Rezoning Transportation Analysis

Petition Number: 2017-203

General Review Information

Figure 7: South Tryon Segment 1 Proposed Section (Near term)

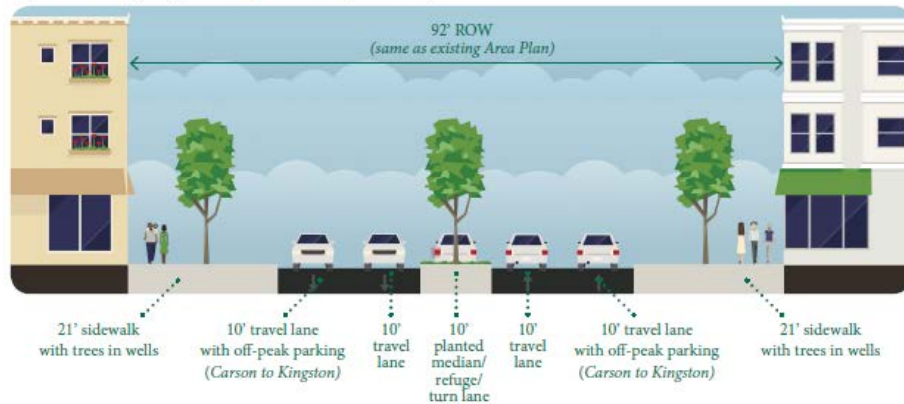
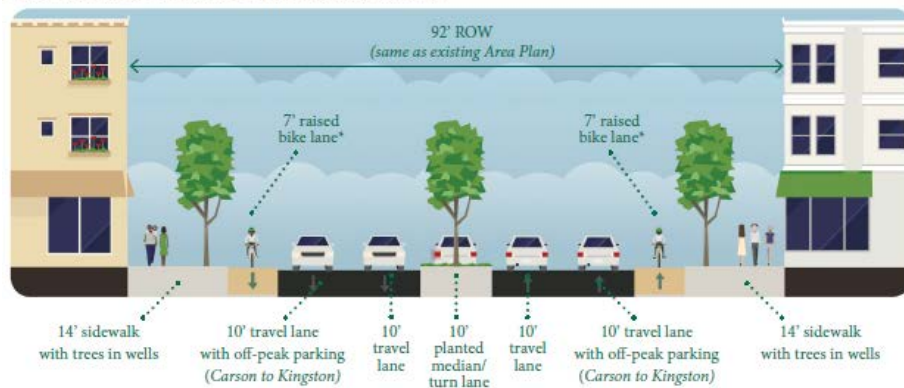
- The recent South Tryon Corridor Study proposed a future cross-section that includes 7 foot raised bike lane. The petitioner should revise the site plan to show the future curbline as noted in Comment 1a for zoning purposes but **construct the interim curbline at 25' from centerline** and remove the future recessed parking on South Tryon St.

Below are the future cross-sections of South Tryon St:
